Re: CA R.18-10-007
CalAdvocates-PacifiCorp-2021WMP-02

Please find enclosed PacifiCorp's responses to CalPA data requests 2.1-2.6. Also provided are Attachments CalPA 2.2 and 2.5.

PacifiCorp’s 2021 Wildfire Mitigation Plans

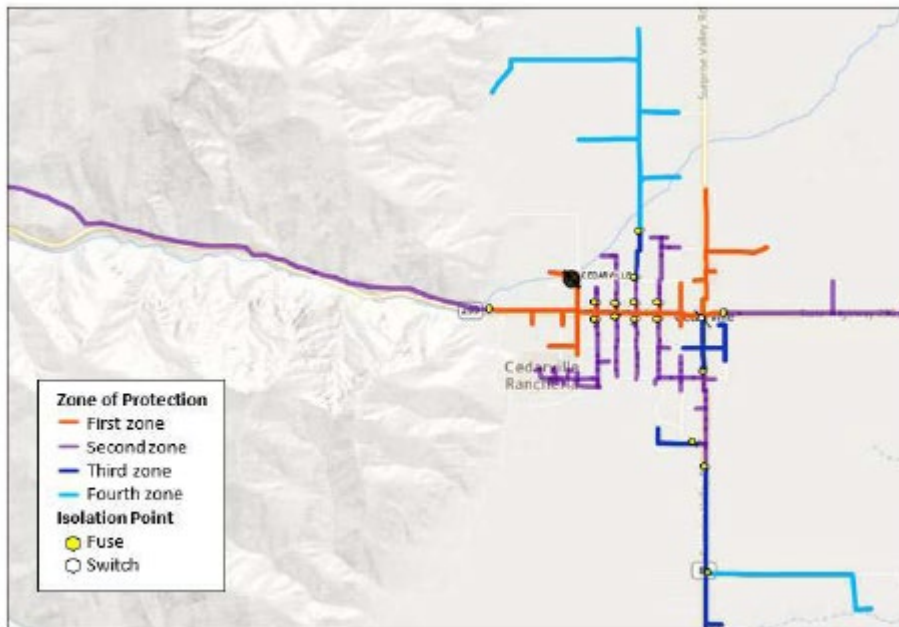
Regarding Zones of Protection (ZOP), PacifiCorp provided a map (provided below) that illustrated how PacifiCorp models ZOPs on page 57 of its 2021 WMP. For calculating wildfire risk, does PacifiCorp calculate (a) one risk score for each of the 17 distinct segments between isolation points as shown on the map, or (b) one risk score for each of the four ZOP categories (i.e., a risk score for First Zone, Second Zone, etc.), or (c) another way not listed above?

PacifiCorp calculates wildfire risk at the zones of protection (ZOP) level, and a specific fire risk score is calculated for each individual ZOP. Thus, in the example referenced above, there are distinct fire risk scores for each of the 17 distinct segments (recognizing of course that it is possible for two segments to have the same score if the calculation for each segment yields the same result). This concept is shown more precisely in Attachment CalPA 2.5 with the specific scores for the example circuit. In addition, further granularity can occur in the individual input layers, depending on the resolution of the data behind the layer, such as associated with the arc energy, for which conductor type changes within the ZOP are the level of resolution, while for climate or tree canopy, the level of granularity is reliant on the level at which weather reanalysis or canopy data may be available, which is generally not as granular.
